Lilydale Township Action Group

Submission to the Victorian Planning Authority

**The Lilydale Quarry Comprehensive
Development Plan**

Amendment C193yan

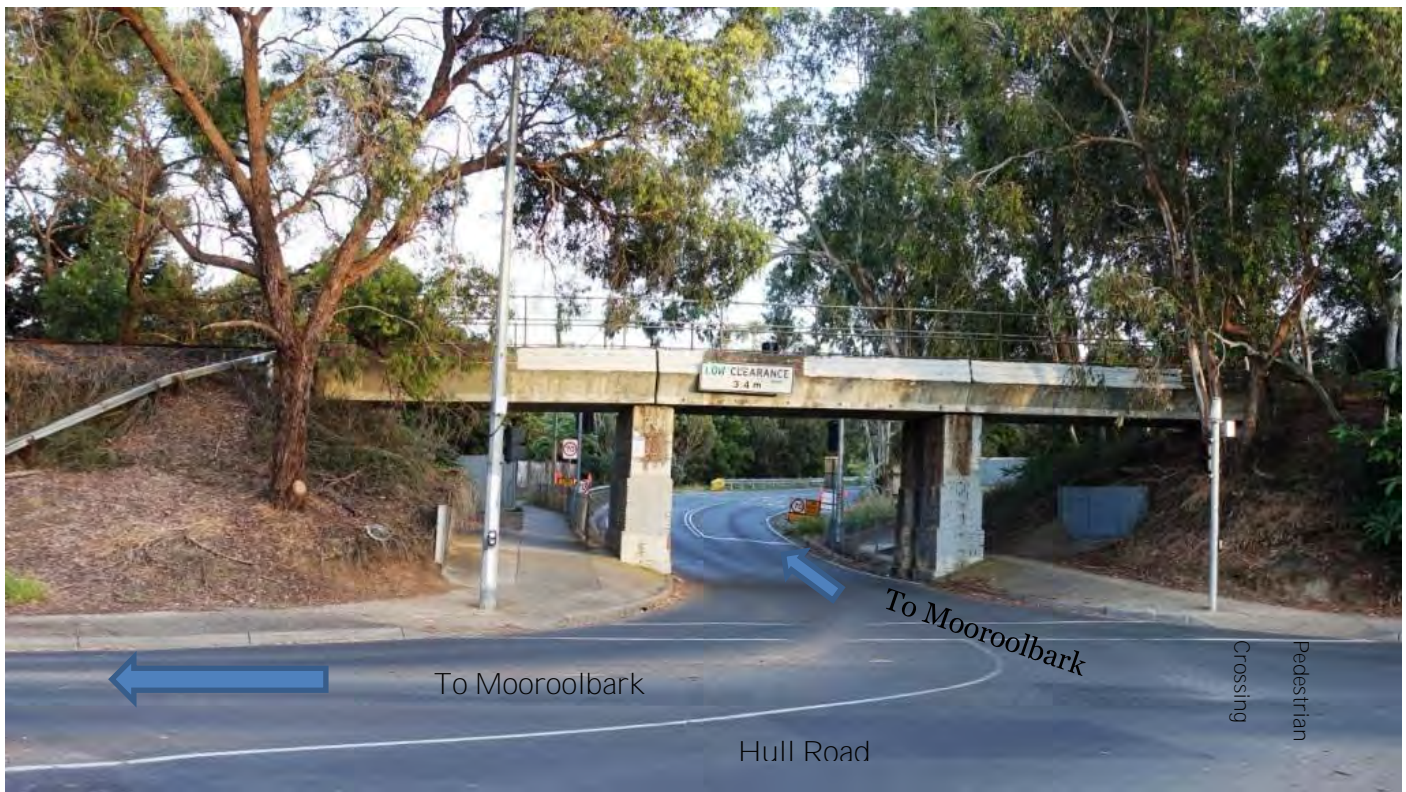
The Hull Rd bridge intersection has traffic lights and they control traffic to flow in a single lane beneath the bridge. The intention is for traffic to flow and not stop under the bridge; however, it is a frequent occurrence for a car to get caught under the bridge by the timing of the traffic lights. When this happens, it is difficult and dangerous for cars turning left or right from Hull Rd into Mooroolbark to pass this stopped vehicle. The bridge is a bottleneck and at peak times on weekday mornings and afternoons, traffic on Mooroolbark Rd banks up for hundreds of metres, and users will have to endure three or more of the traffic light cycles. The low clearance (3.4metres) regularly catches higher vehicles that sometimes get stuck and/or block traffic performing a dangerous and disruptive U turn to reroute. Even though there are pedestrian signals at the intersection there are many near misses and crossing is extremely hazardous, especially for children. Another dangerous manoeuvre is a right-hand turn from Balcombe Rd. On many occasions this is only possible by other drivers giving way.

The rail bridge itself appears to be dilapidated and nearing the end of its' useable life. It currently prohibits duplication of the rail line between Mooroolbark and Lilydale and without this duplication the proposed Kinley Station will not maximise its usefulness, as stopping at this station will only extend travel time for Lilydale commuters and possibly cause more rails service disruptions. Page 40 DI-RD-07b refers to the existing rail bridge but is not clear on the scope only that it is to facilitate proposed road works under DI-RD-07a which the community believes does not go far enough to remove existing safety/rail capacity restrictions.

Please see the photos of the bridge and retention walls and pedestrian crossing on this page and Pages 5 & 6
